Sunnyside Cogeneration Associates

RE: Star Point Waste Fuel - Permit # C/007/042
Permit Amendment – Roads D, F & L Task ID #3653

APPLICATION FOR COAL PERMIT PROCESSING

Title: Roads D, F & L

SCA / STAR POINT WASTE FUEL
PRIMARY ROAD L
PLAN, PROFILE AND CROSS-SECTIONS

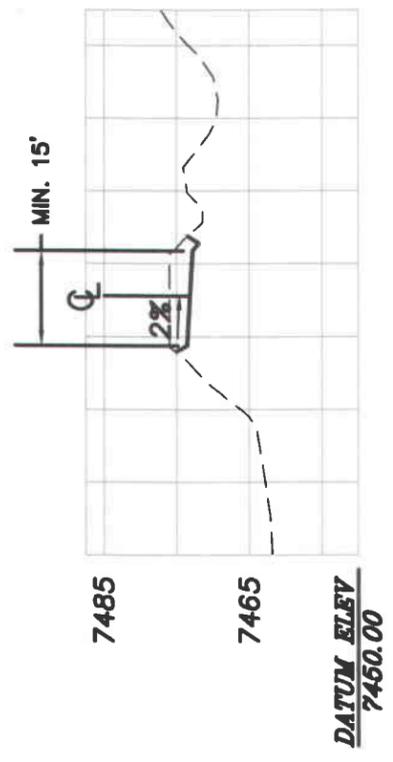
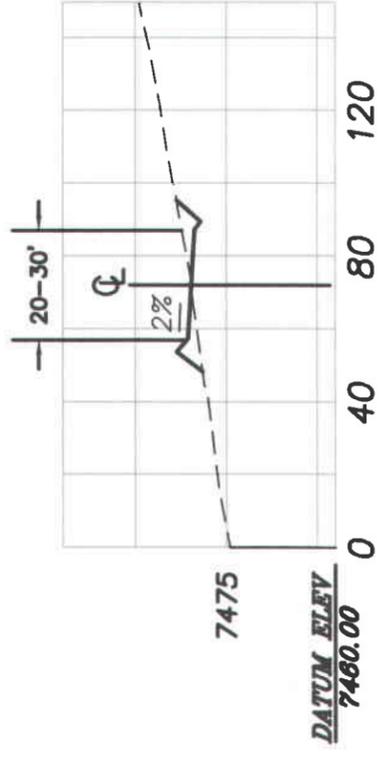
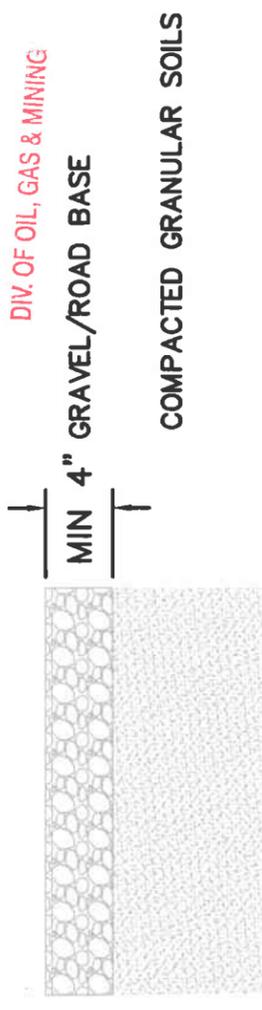
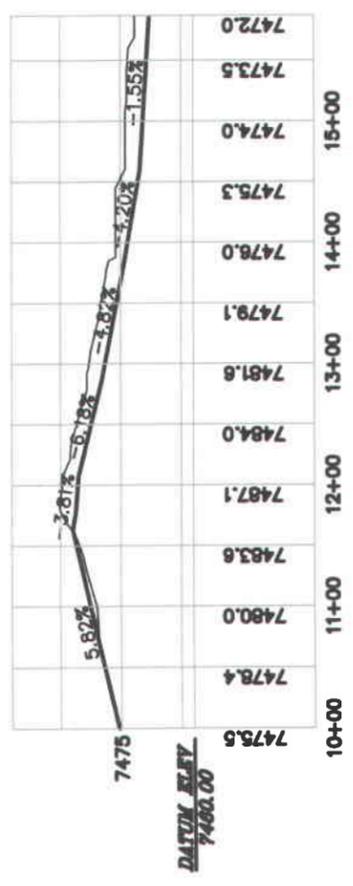
Primary Road L (Access to Refuse Pile A and Disposal Area) – The one way access road to the middle of Refuse Pile A and the Disposal Area is called Road L. The road is approximately 15 to 30 feet wide and the grade ranges from 0% to 6.2%. This road is surfaced with gravel or road base. The road provides additional access to the south side of Pond 9. Construction efforts to upgrade this ancillary road to the primary road are expected to begin within 1-2 years following DOGM approval.

SCA / STAR POINT WASTE FUEL
PRIMARY ROAD D
PLAN, PROFILE AND CROSS-SECTIONS

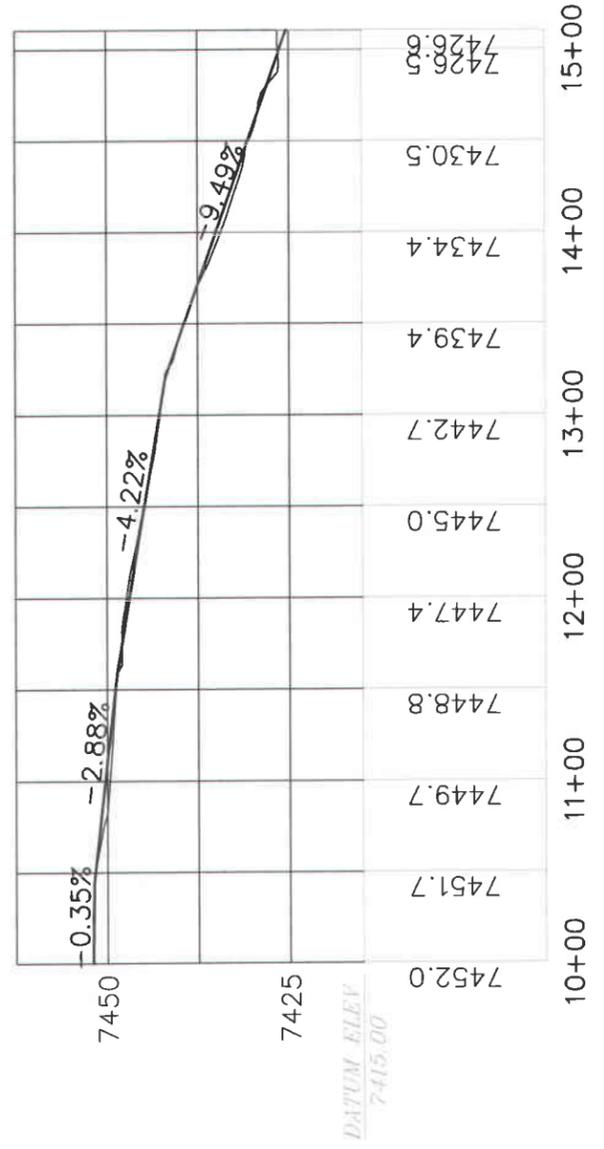
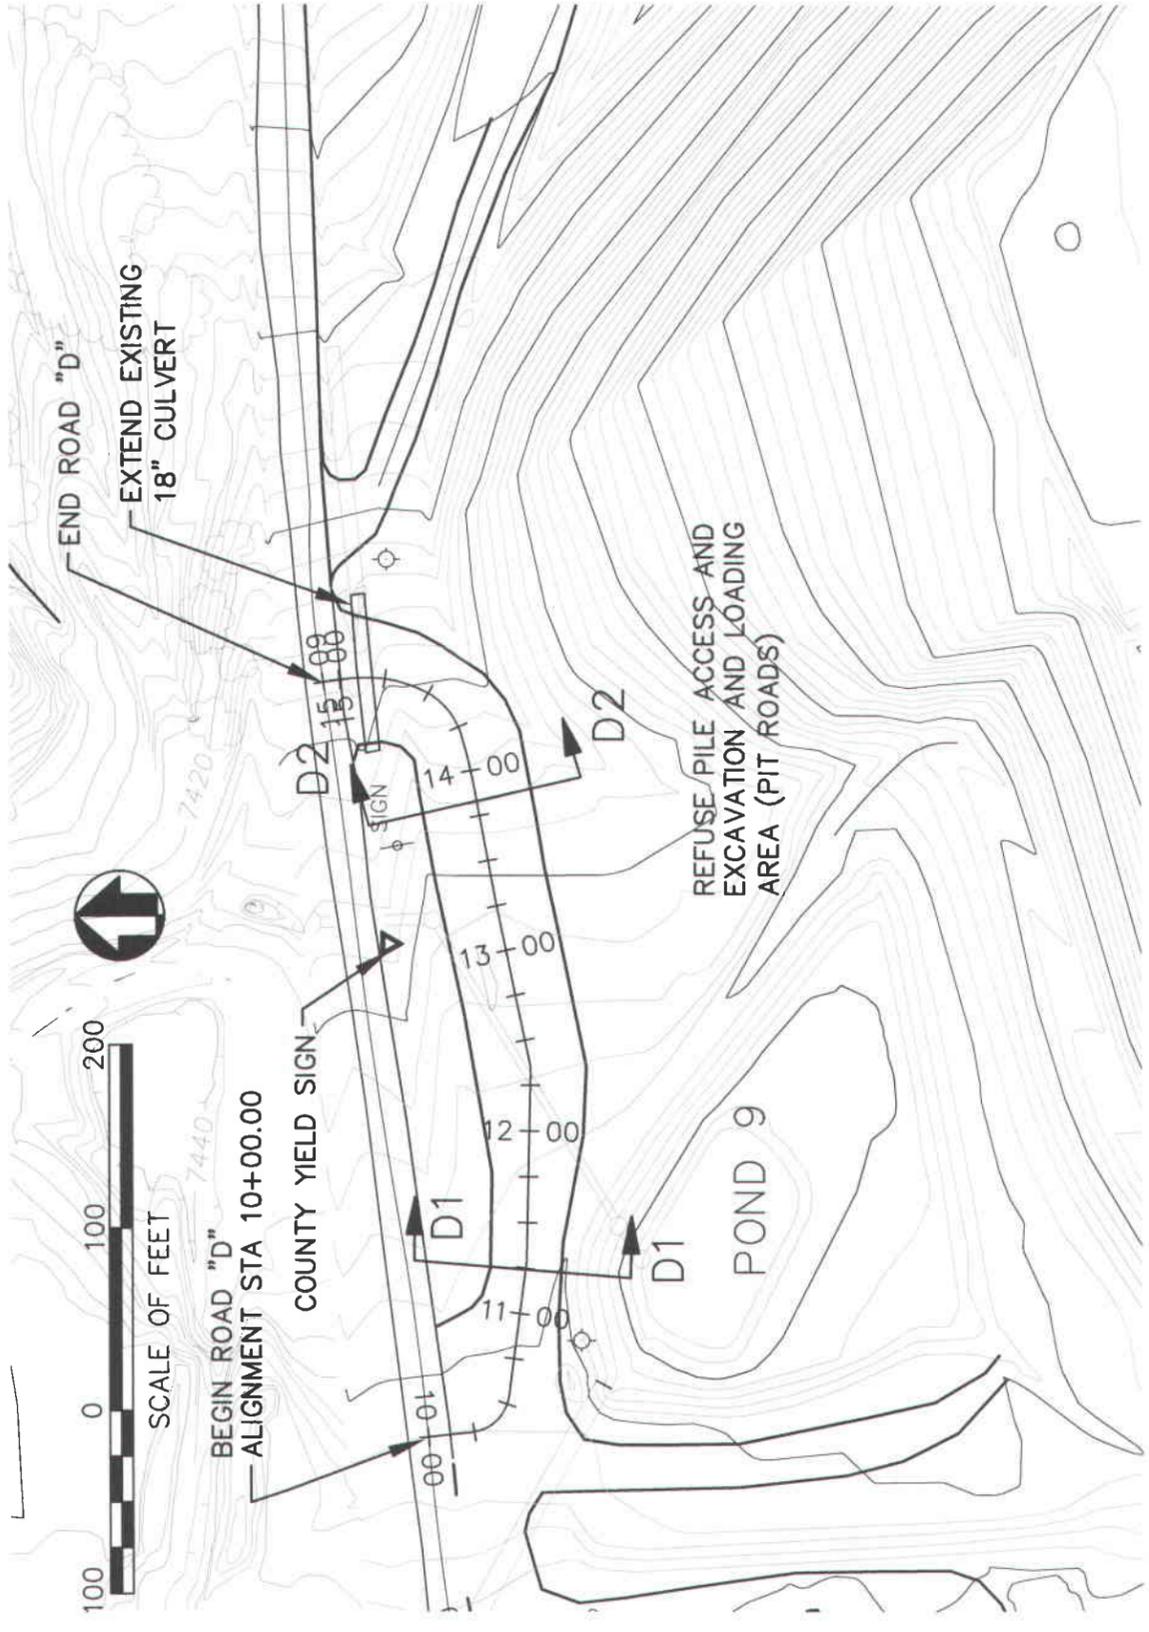
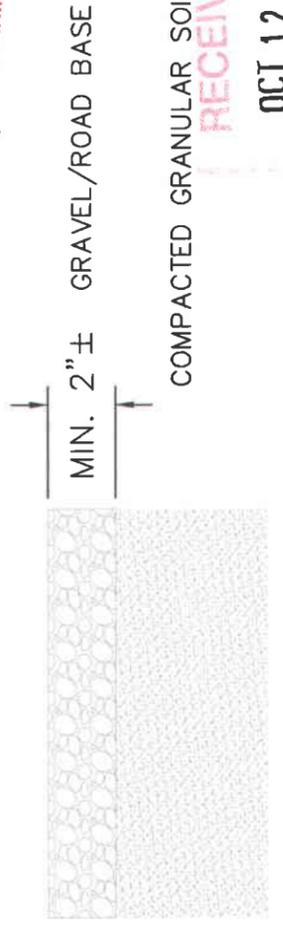
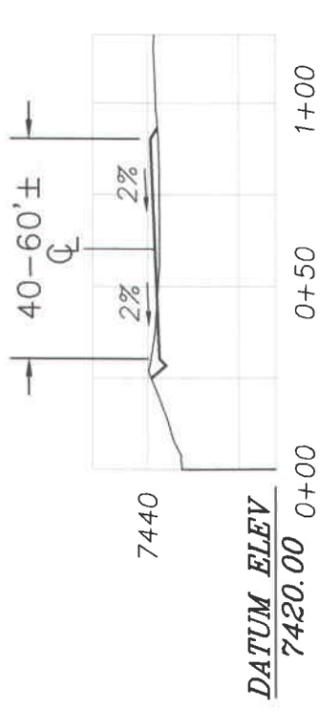
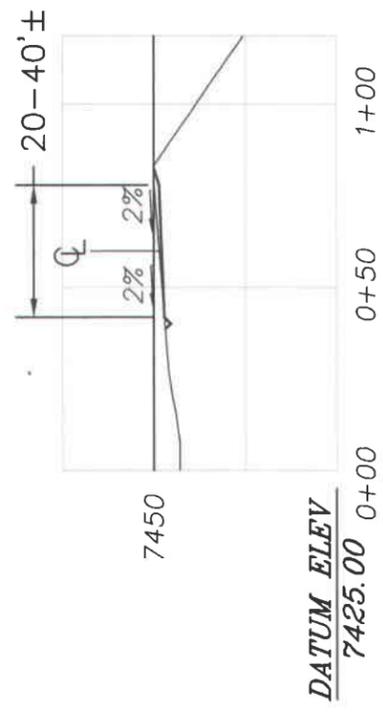
Primary Road D (Access to Refuse Pile A) – This access road is intended for regular use by haul trucks to provide access to the northeasterly point of Refuse Pile A. The 20'-60' wide road will have a gravel or road base surface and a grade that ranges from 0% to 10%. This road will also facilitate loading of excavated material from the refuse pile. Construction on this primary road will begin within 1-2 years following DOGM approval.

SCA / STAR POINT WASTE FUEL
PRIMARY ROAD F
PLAN AND PROFILE

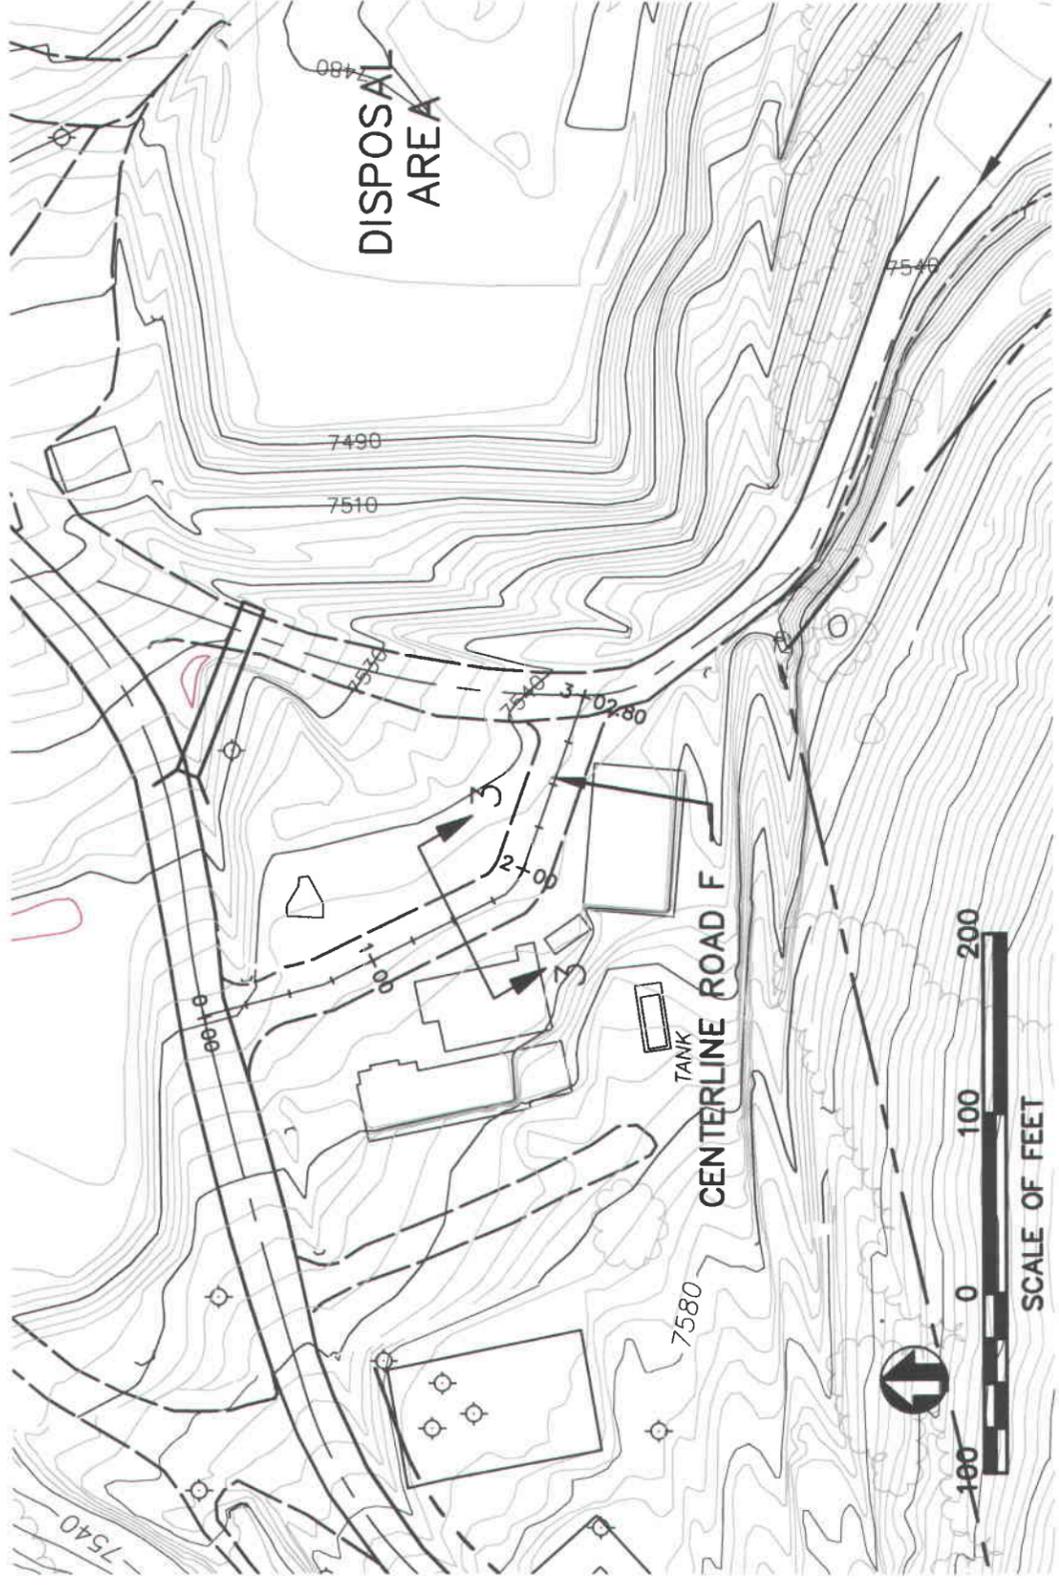
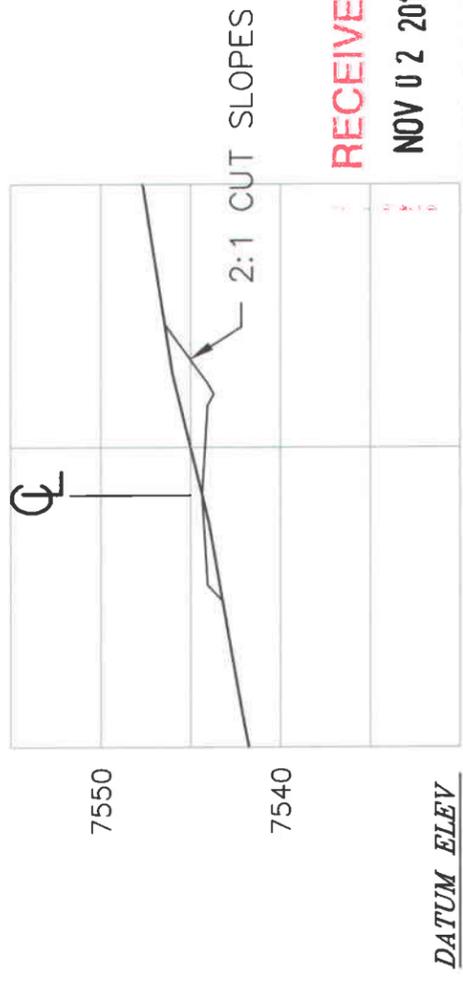
Primary Road F (Access to Refuse Pile A) – This access road is intended to provide an access road to the refuse pile at a more gentle grade than the Primary Haul Road and facilitates more efficient travel. The 15-35 ft road will have a maximum grade of 5% and crosses portions of old asphalt parking lot and also has a gravel surface.
